Proposal for a supplement 11 to the 03 series of amendments to UN Regulation No. 51

This proposal concerns to amendments to Annex 7 of UN Regulation No. 51. The proposed changes are based on the 03 series of amendment to UN Regulation No. 51 up to Supplement 09. The modifications are marked in bold for new or strikethrough for deleted characters.

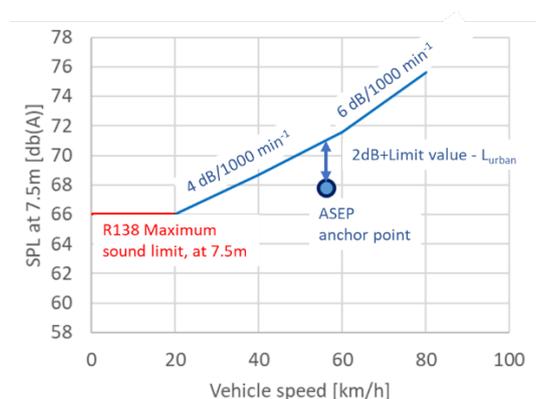
AVAS Levels are regulated in UN-R138. To create a handshake between UN-R138 and UN-R51 Annex 7 at 20 km/h, OICA proposes to use a constant value of $5 \text{ dB}/1,000 \text{ min}^{-1}$ for Slope_κ .

With Slope_κ set to the maximum value, most ambitious ASEP Limits are created between 20 to 50 km/h with $4 \text{ dB}/1,000 \text{ min}^{-1}$.

When set with a limit for L_{urban} at 68 dB(A) for a vehicle with a non-locked transmission, this value of Slope_κ provides limit values that match the value of 66 dB(A) at 20 km/h, which is the equivalent of the 75 dB(A) limit for maximum sound level in UN Regulation 138. This handshake is illustrated in the figure above.
